UNITED STATES PATENT AND TRADEMARK OFFICE

APPLICATION NO.	FILING DATE	FIRST NAMED INVENTOR	ATTORNEY DOCKET NO.	CONFIRMATION NO.
10/764,101	01/23/2004	James A. Harrington	879.1.018	7908

Office Action Summary

DETAILED ACTION

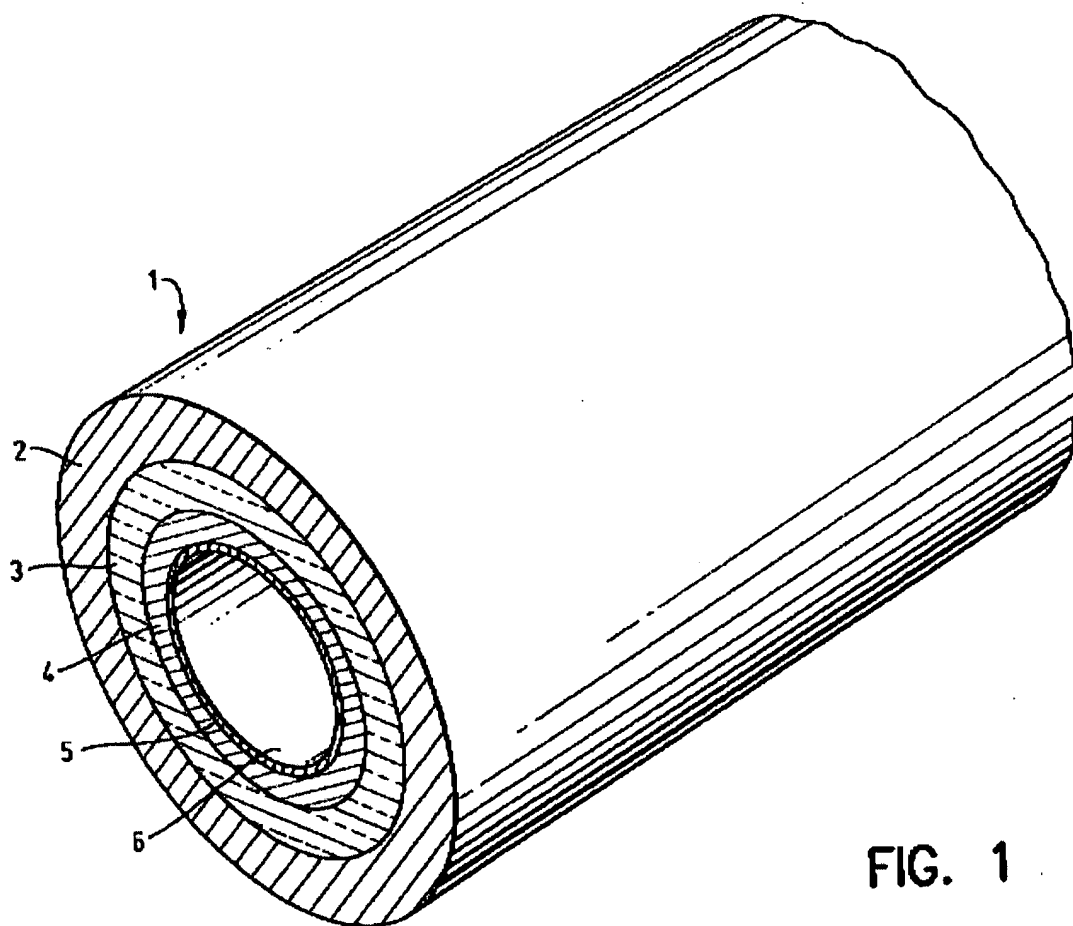
With respect to claim 33, Harrington (figure 1) discloses a method of fabricating a flexible, hollow waveguide using liquid phase deposition, comprising the steps of (a) depositing a metallic layer (4) on a smooth, inner bore surface of a hollow, flexible, silica-glass tube (3); and (b) depositing a sulfide layer upon the metallic layer (4) of step (a) (see column 6, lines 28-32 and 48-52).

Harrington does not explicitly disclose a cadmium sulfide layer, which deposited upon the metallic layer.

However, the cadmium sulfide layer is considered to be obvious. Therefore, it would have been obvious to one having ordinary skill in the art at the time the invention was made to deposit upon the metallic layer of Harrington's device with a layer made by the material as claimed for the purpose of obtaining higher efficiency of optical signal transmission. It is also noted that it has been held to be within the general skill of a

worker in the art to select a known material on the basis of its suitability for the intended use as a matter of obvious design choice. *In re Leshin*, 125 USPQ 416.
